Proposed VSW1 CPZ extension in Cottenham Drive, Cottenham Place and High Cedar Drive – statutory consultation.

Committee: Cabinet Member Report

Subject: Proposed VSW1 CPZ extension in Cottenham Drive, Cottenham Place and High

Appendix 3 - Representation and Officer's Comments

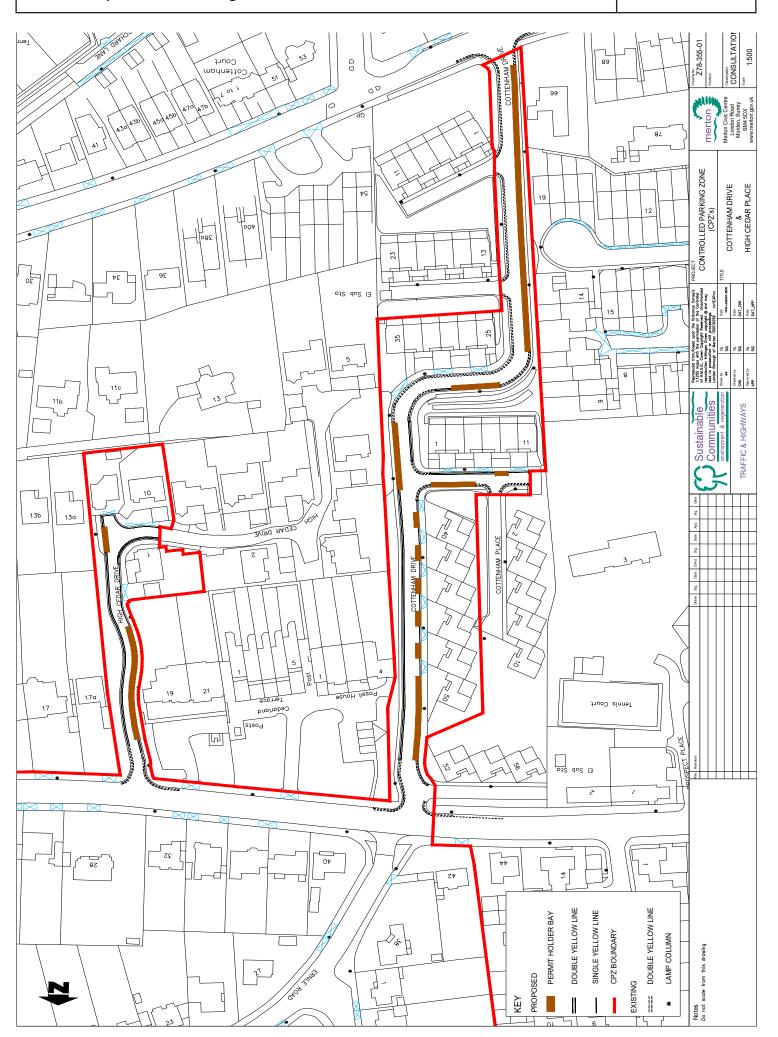
On behalf of the Board of the 'Homeowners Association', we refer to the map (Z78-255-01) showing the boundary of the proposed VSW1 controlled Parking Zone. Unlike CPZ boundary lines on previous Raynes Park proposed CPZs which recognised the Copse Hill Estate as a contiguous whole, the new boundary fragments the Estate.

We request that the west boundary of the CPZ area be adjusted to follow the boundary between Prospect House/Place and Copse Hill Estate.

Your CPZ Boundary outlined in red on Drawing Z78-355-01 incorporate 3 of our Private Roads which have not been adopted by Merton Council, i.e. 1-11 Cottenham Drive.

However, in your plan, you have indicated that the area designated for permit parking in front of our row of 6 houses (starting from no 25-35 Cottenham Drive) is to be reduced from the current size, which currently allows four cars to park. I seriously object to this and would like the size of this section to be kept as it is please.

- 1. Properties 2-10 Cottenham Place to be included in the scheme as per all other residents of Copse Hill Estate. Although portions of the estate have been adopted as public roads it was designed and constructed as one entity. Omitting these properties would significantly restrict their access to parking, whilst all other properties on the estate, public or private roads would still be able to park anywhere on the estate. The excluded portion of Cottenham Place has fewer parking spots than properties.

- 2. Additional bays to be located on the North Eastern end of Cottenham Drive. The CPZ proposal has limited parking spaces to the north of the estate, addition of single yellows or residents' bays would at least allow parking when required, and reduce the already frequent overspill parking in the unadopted streets. Presently there is parking on both sides of the road at this location and the road width is greater than that of neighbouring Ernle Road where there is double parking along the length of the street, as such road safety and/or traffic flow cannot be deemed reasonable justification for blanket double yellows along this section of the road.

Regarding the design of CPZs, it is normal practise to exclude properties in the private section of a road in a proposed CPZ. Therefore, a decision has been taken not include the private sections of Cottenham Drive and Cottenham Place.

However, as there are no pay and display parking spaces in Cottenham Drive / Place, it is recommended that property nos. 1-23 and nos. 52-56 Cottenham Drive and nos. 2-10 Cottenham Place (even numbers only), properties within the unadopted (private) sections of the estate, be eligible to purchase visitor parking permits only and not eligible for resident parking permits in the event of the scheme's implementation.

The layout of the parking bays are arranged in a manner that provides the maximum number of suitable parking spaces without jeopardising road safety and the free movement of traffic.
